## EXHIBIT C ARRL PETITION FOR RECONSIDERATION

#### Analysis of Distance Extrapolation of Field Strength Calculated from the Antenna Models Provided to the FCC in the BPL Notice of Rulemaking Comments and Reply Comments

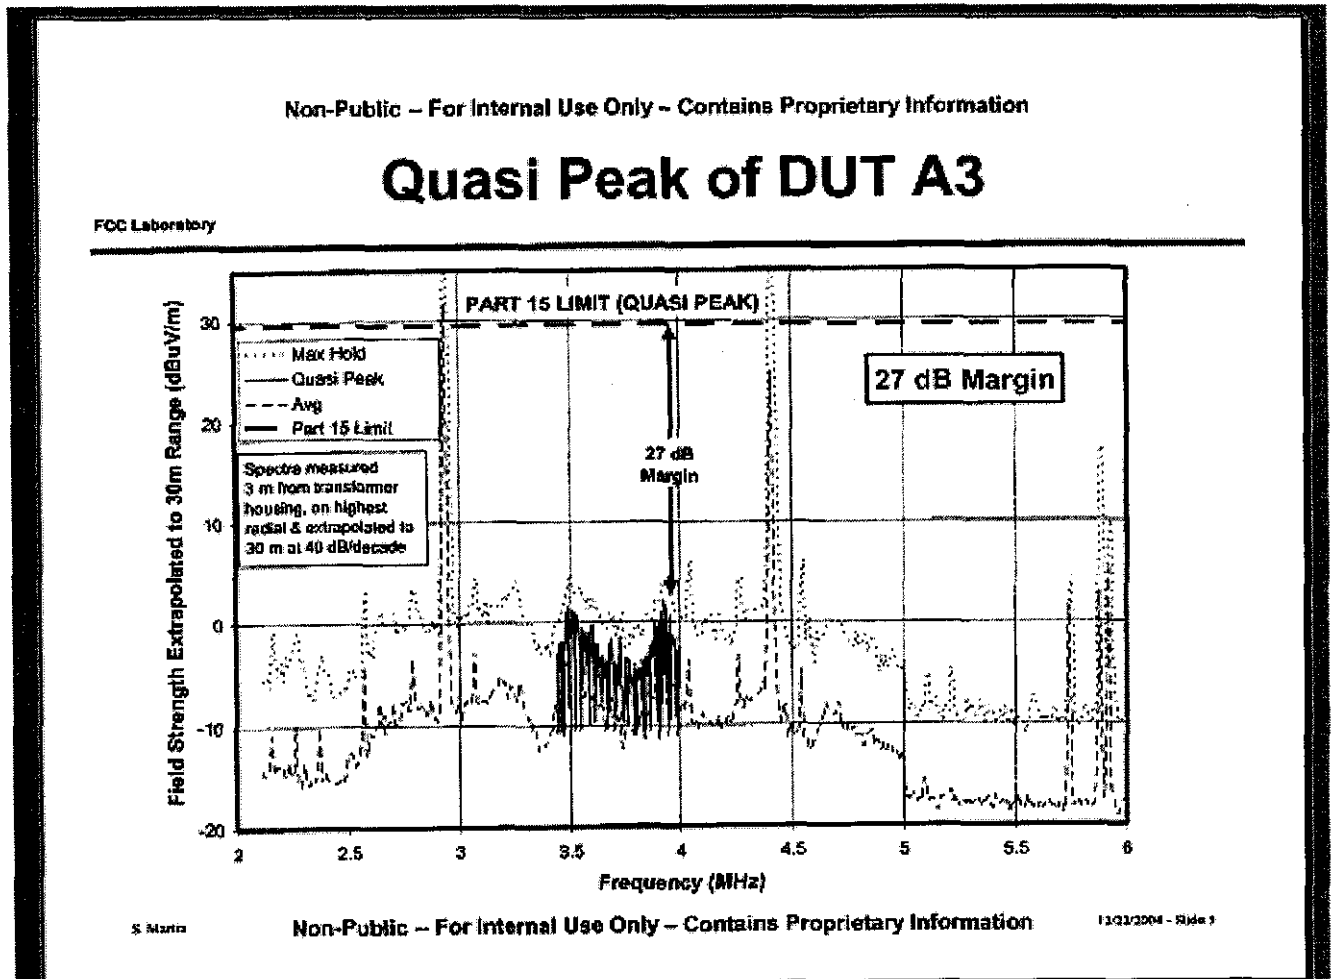
Figure 24 -- This measurement was taken 3 meters from ground-mounted BPL equipment in Allentown, PA. It shows an extrapolated noise level as low as -18 dBuV/m/. If this were extrapolated to 10 meters distance – the approximate distance of ARRL ambient-noise level measurements from power lines – the minimum noise level shown on this graph would be at a level of +2.9 dBuV/m. If this level was observed by the Commission immediately adjacent to a BPL device, it was not reasonable for the

Commission to reject ARRL's measurements of 0 dBuV/m to -10 dBuV/m in areas where no BPL is present.
